Sustainability

The Current Proposal 2011

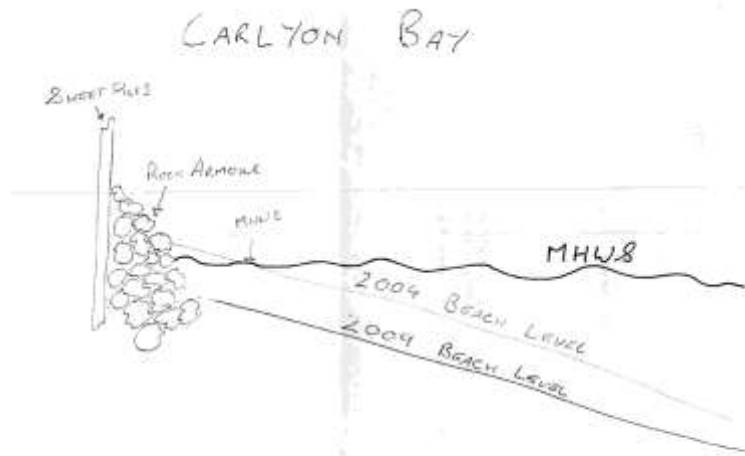
labelled 1782_pl_100_existing site plan, ORMS Detailed Drawings, one can see annotated 'Mean High Water Survey 2003' and 'Mean High Water Survey 2006'. The 2006 MHW is substantially landward of the 2003 MHW point.

- 3.5. For further confirmation of the landward movement of the MHW I draw your attention to copies of correspondence between Mr Roy Bennett and the MCEU with regard to the FEPA licence issued for the placement of the rock armour, temporarily below mean high water springs (MHWS). In that correspondence Mr Bennett points out that although the FEPA licence was issued on the basis that the rock armour would be placed below MHWS but subsequently moved above it, the action of placing the steel shuttering and the rock armour had so scoured sand from the beach frontage that the rock armour was now indeed within the MHWS. This was agreed by the MCEU in a letter dated 18th January 2009 in which Mr Ricky Evans, Consent Manager (West Coast) wrote:

The sequence of events suggest it is most likely that between 2004 when the licence was issued and present time, coastal processes have migrated the line of MHWS and thus the area previously considered landward of the MHWS mark is now well within the inter-tidal area. A simple diagram, which I also enclose, may assist to illustrate this."
